ADDENDUM NO. 3

SUBJECT: Solicitation No. AA018B

TITLE: Miami International Airport (MIA) South Terminal Concourse H Rehabilitation – Phase 1

ATTACHMENT 1

| DRAWING NO.: | A-7 |

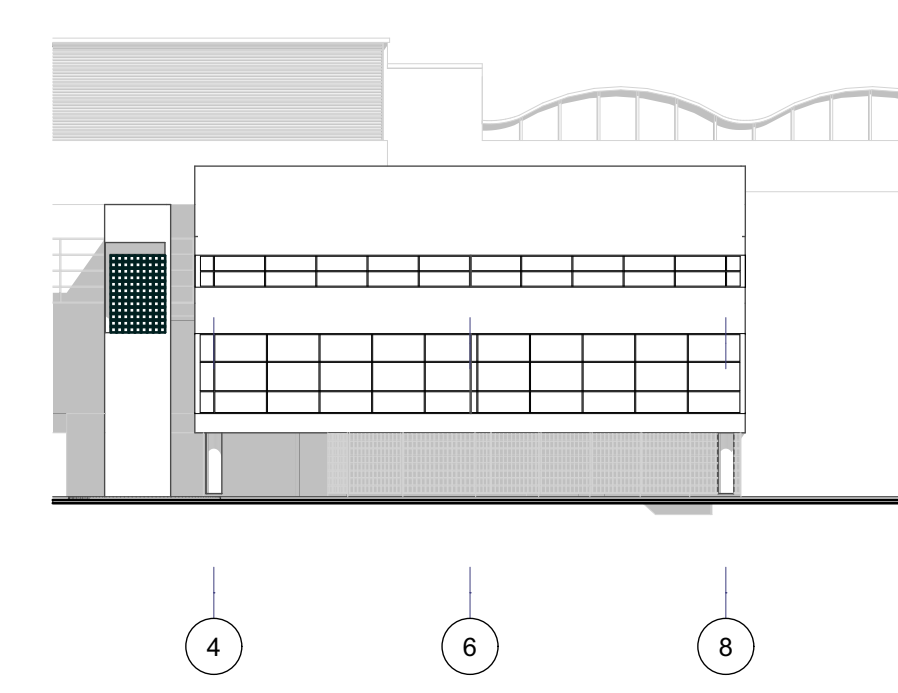
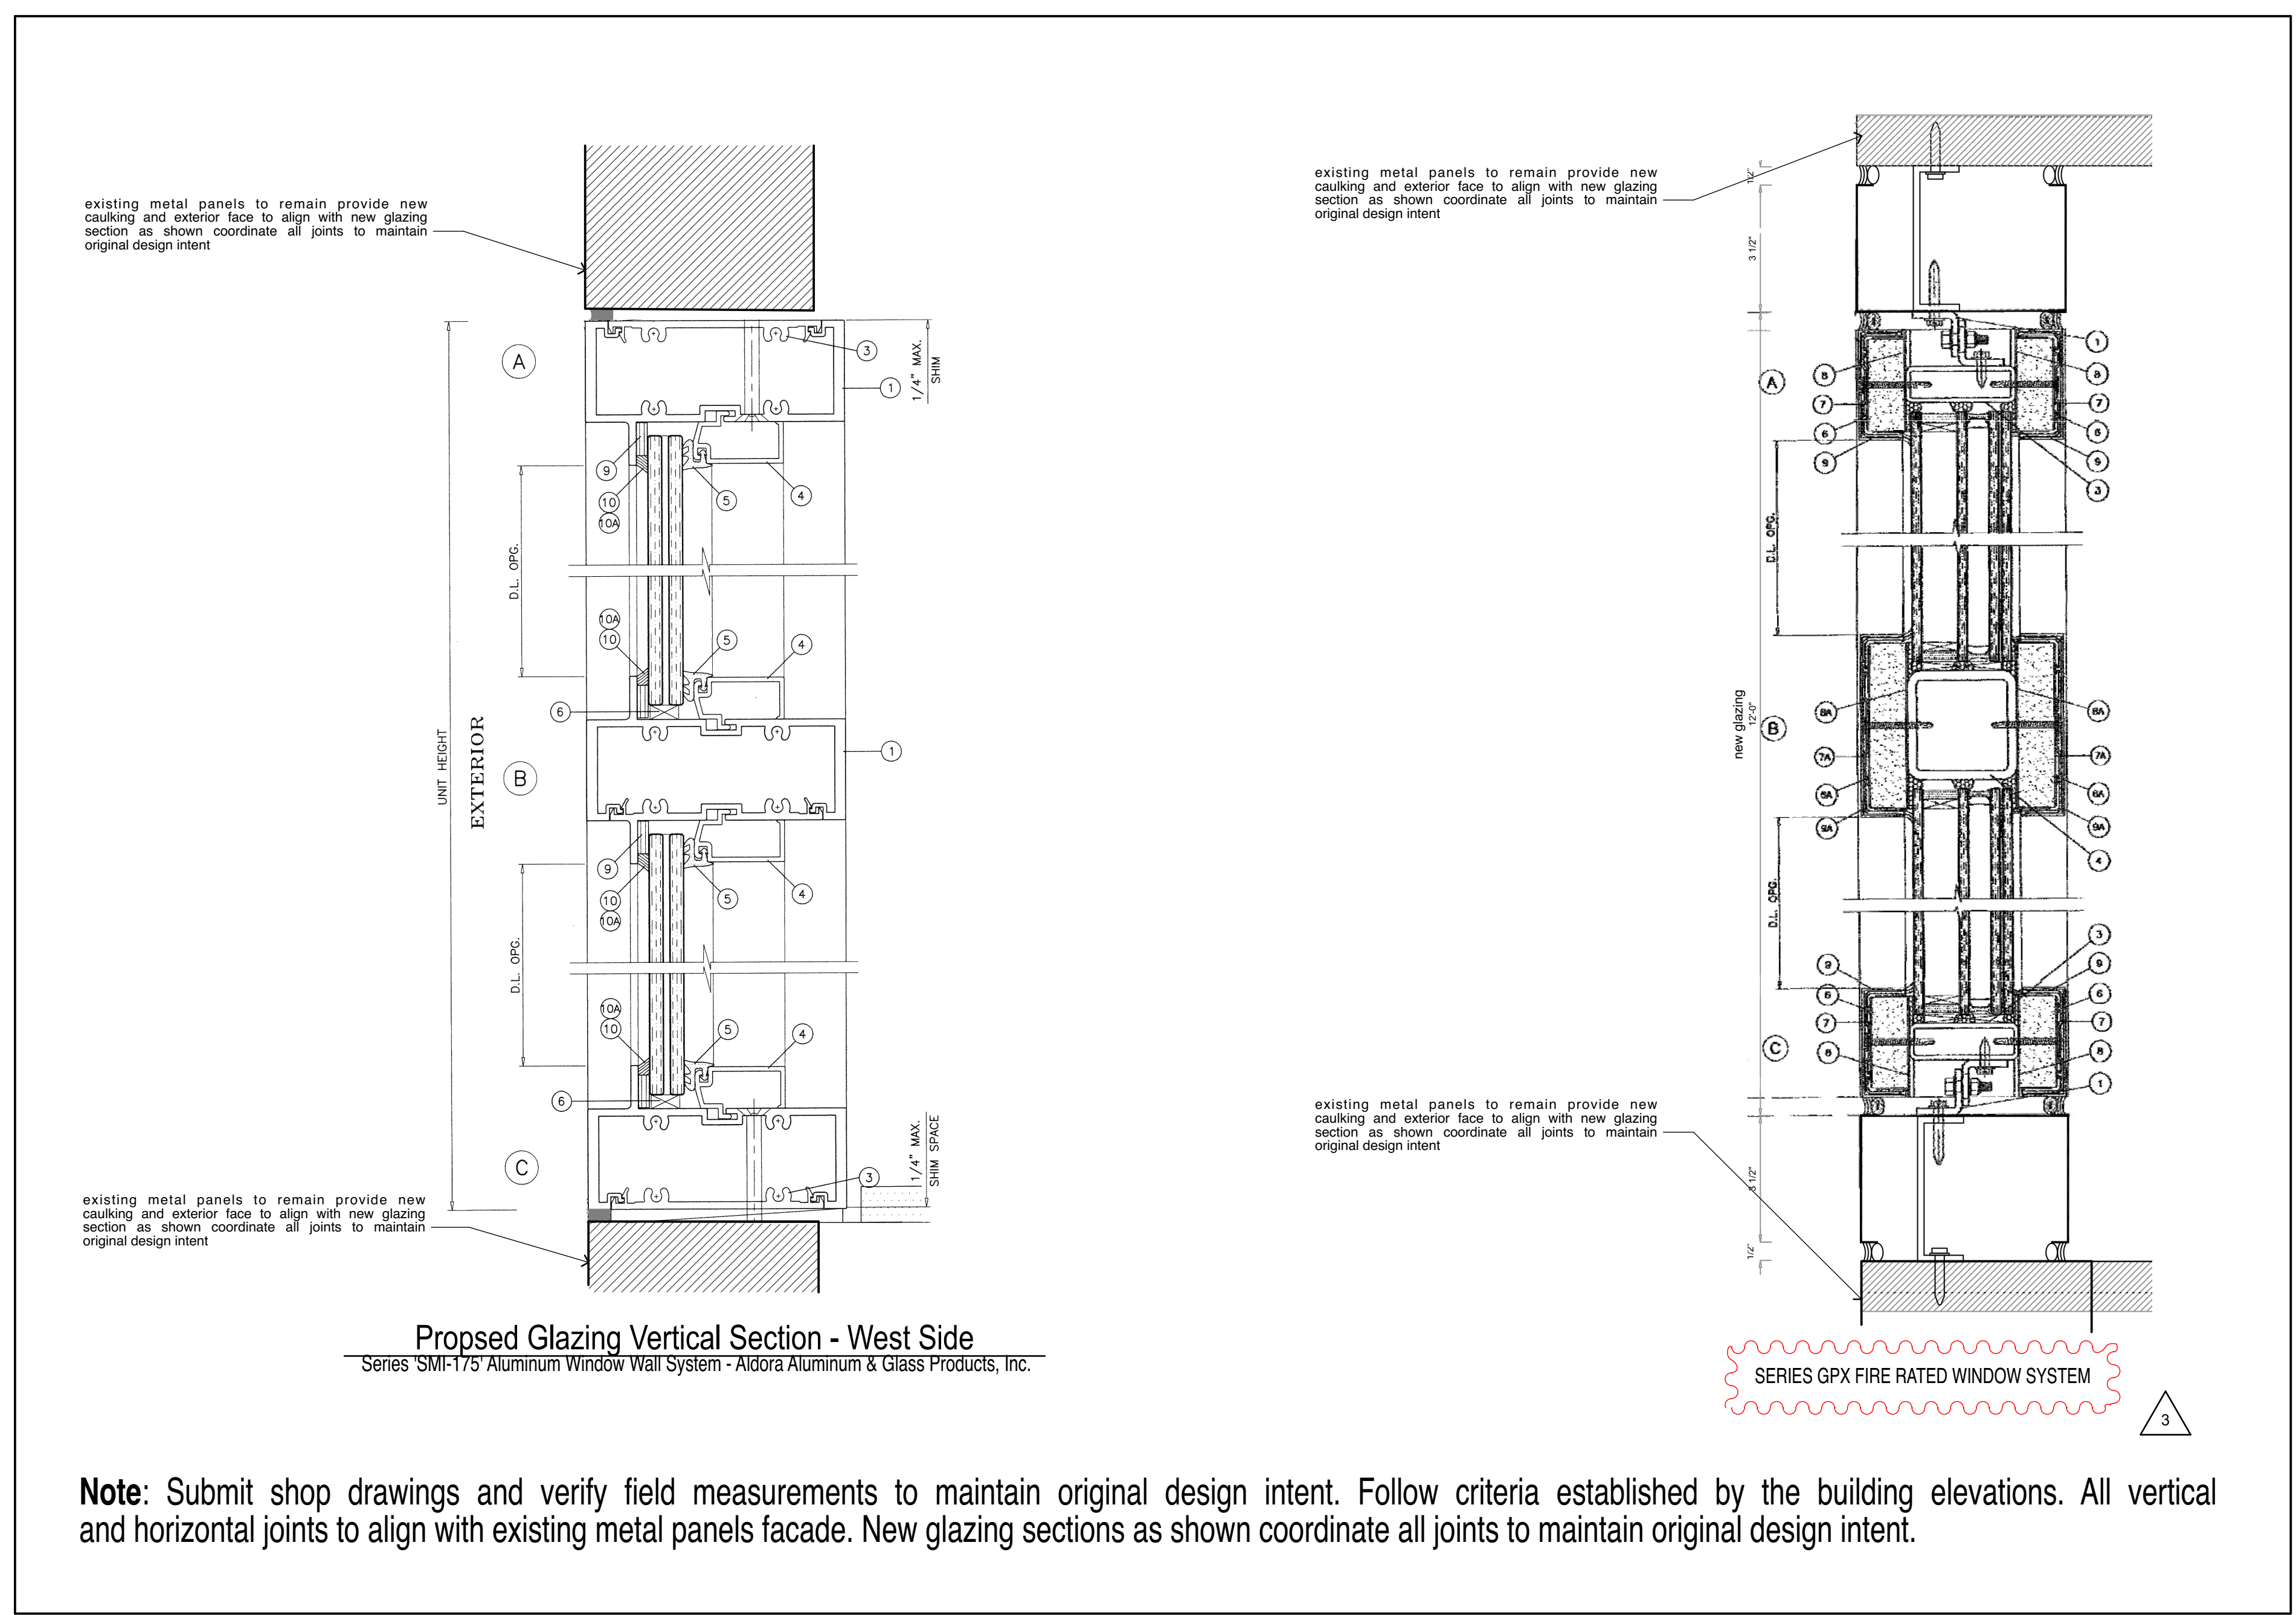
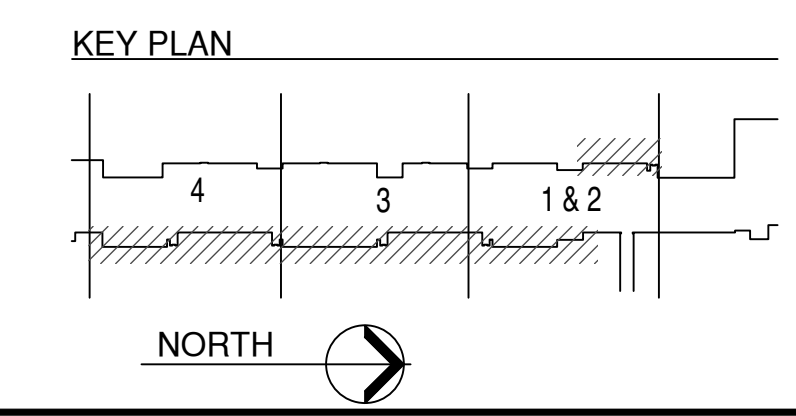
Question No. 4 Part 4. Sheets S1.08 & S109 building elevations specify the existing metal cladding to be protected where the storefronts/curtainwalls are been replaced. Please provide contractually what the owner is requiring from the contractor in adhering to this note, so we can price this work accordingly.

Answer No. 4 The existing metal panels are to remain in their existing condition. The Contractor will provide appropriate methods and materials needed to protect the metal cladding from damage including temporary removal if necessary. Refer to Addendum No. 2, Revision C, C, S1.07, and Addendum No.3, Attachment 1.

Note: Submit shop drawings and verify field measurements to maintain original design intent. Follow criteria established by the building elevations. All vertical and horizontal joints to align with existing metal panels facade. New glazing sections as shown coordinate all joints to maintain original design intent.
